Z-41
(2016)

SURVEY FOR:
LORI FOWLER
PARTS OF LOTS 1 & 2, BLOCK H, VINING HEIGHTS, SECT. 6
LAND LOT 816, 17th DISTRICT, 2nd SECTION
COBB COUNTY, GEORGIA
SCALE: 1"=40' DATE: MARCH 8th, 2016

PETITION NO: Z- 41

Z-41 SHELBY WORKMAN ESTATE

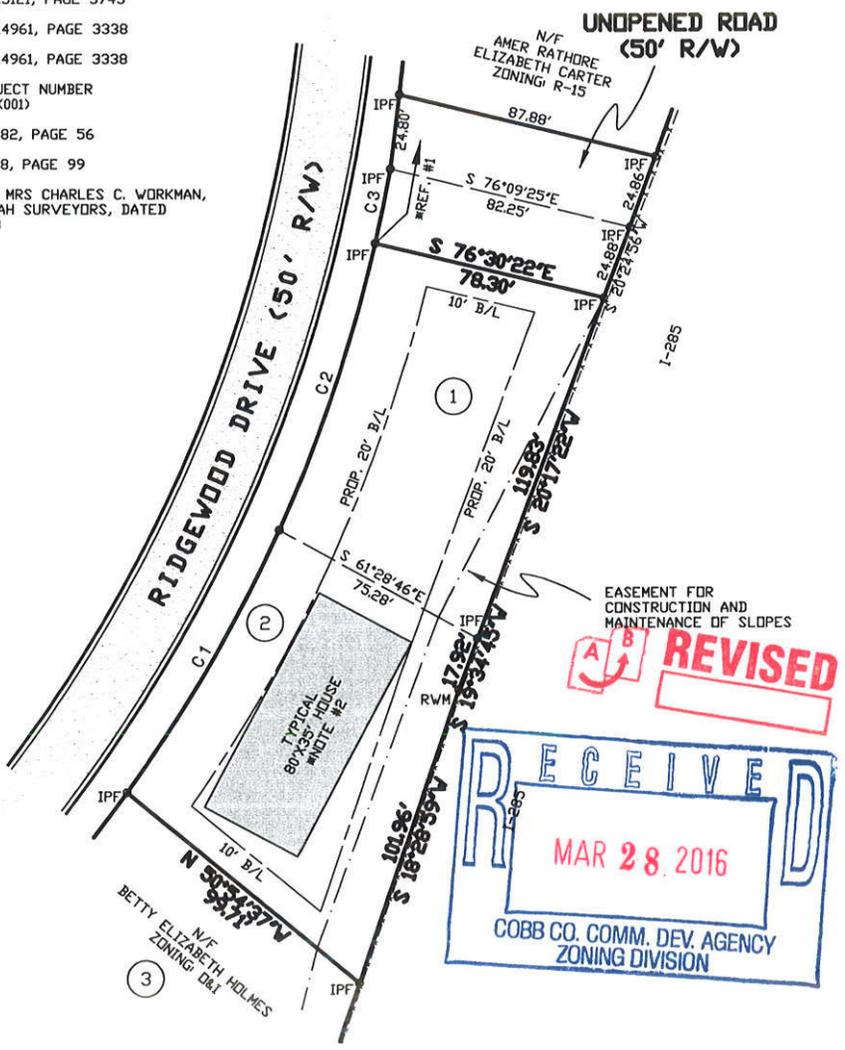
- Reduce the rear setback from 30 feet to 20 feet;
- Reduce the front setback from 35 feet to 20 feet.

Site Plan Review: If this rezoning request is approved, a subdivision plat revision must be recorded prior to the issuance of the building permits showing the approved lot configuration and referencing the rezoning case in the standard plat revision note. The surveyor must submit the plat to the Site Plan Review Section, Community Development Agency for review and approval prior to recording. Call 770-528-2147.

- Revised site plan received by the Zoning Division on March 28, 2016, with the District Commissioner approving minor modifications;
- Water and Sewer Division comments and recommendations;
- Stormwater Management Division comments and recommendations;
- Department of Transportation comments and recommendations.
